HITCHCOCK ROAD SAND EXTRACTION AND REHABILITATION PROJECT MAROOTA

SUBMISSIONS REPORT

March 2008

DFA Consultants

Figure 3.2
DEVELOPMENT SETBACKS

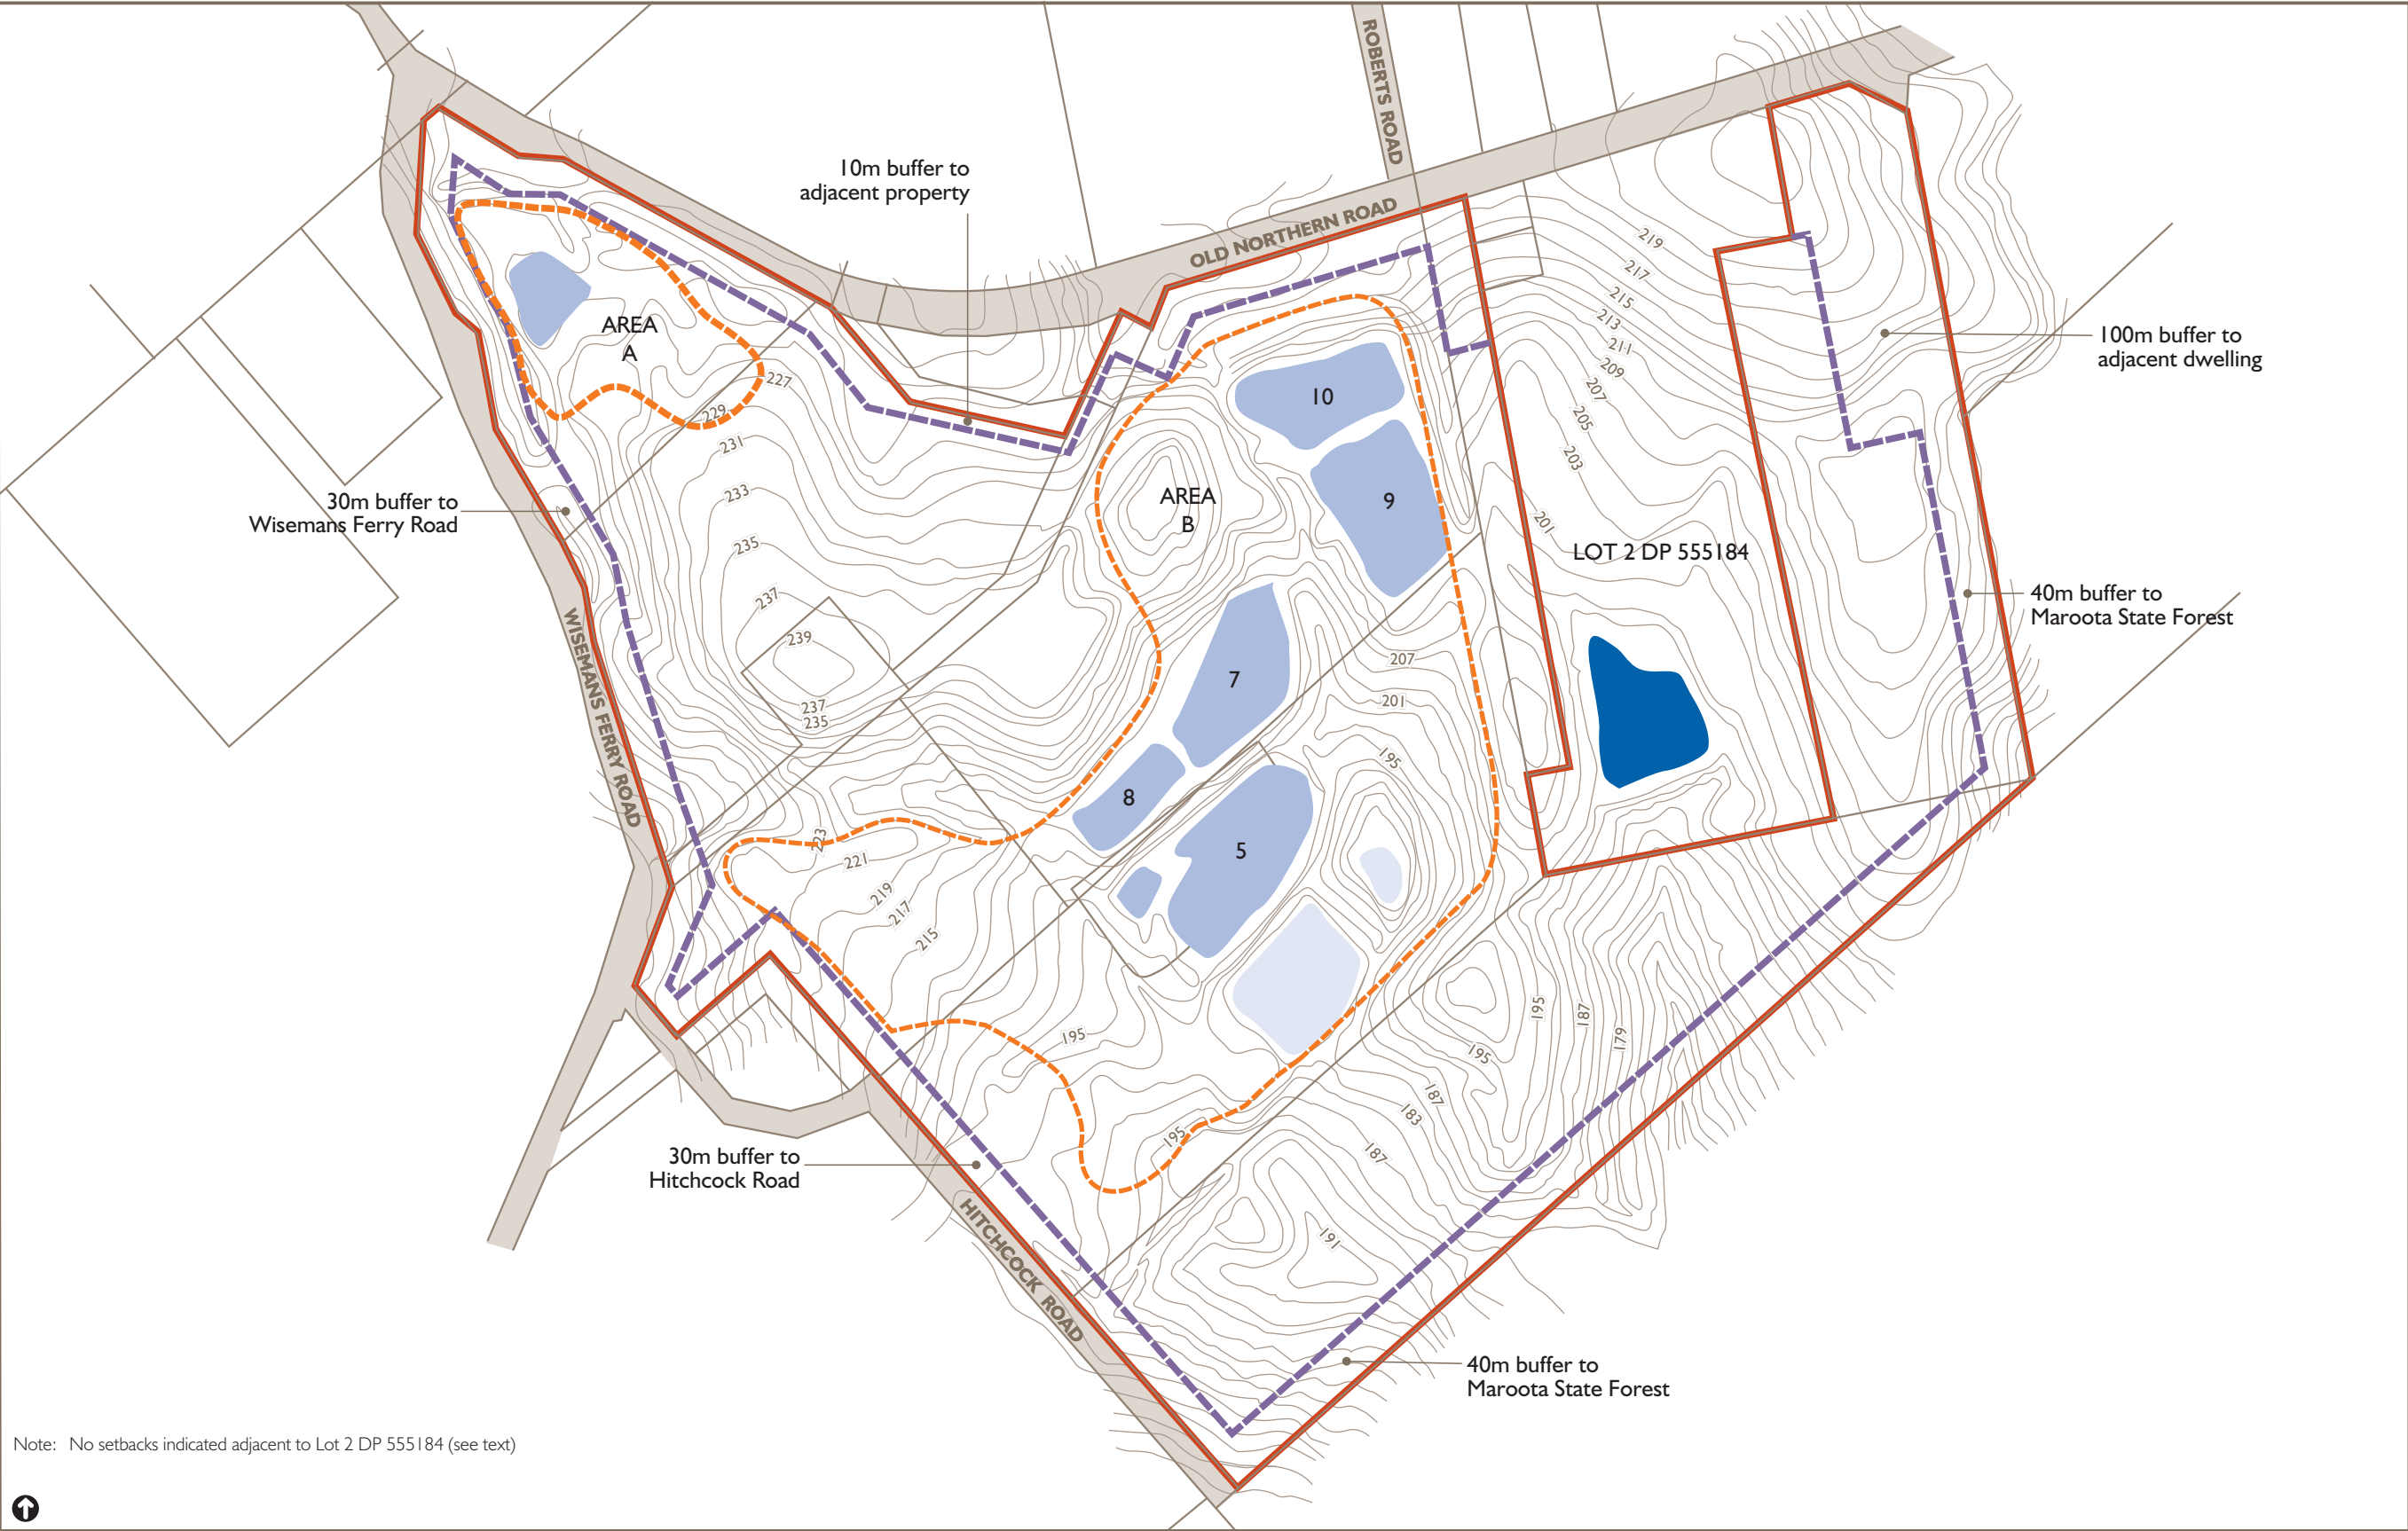
Issues relating to compliance with the setback provisions of Part D, Section 6 Extractive Industry of Baulkham Hills Development Control Plan 9.

Lot 1 DP555184 and Lot 3 DP542117, not included in the proposal, were inadvertently omitted from Figure 2.3. Their inclusion will result in minor changes to the plans.

- A setback of 30 metres from the Rural Fire Brigade facility on Lot 3 DP542117 and the disused Scout hut on Lot 1 DP555184 is shown on **Figure 3.2**. Due to the nature of this facility, activities at this location are not likely to be disturbed by adjacent sand mining and the 100 metre setback included in DCP 16 is considered to be excessive.

The amended setbacks reflecting these circumstances are shown on **Figure 3.2**.

- No changes are proposed to the environmental management measures although a minor rewording to the Statement of Commitments has been made.
- Having considered the submissions received, the proponent is satisfied that the proposal as described in the EA could proceed with the only modifications relating to the setbacks as described above and shown in **Figure 3.2**.
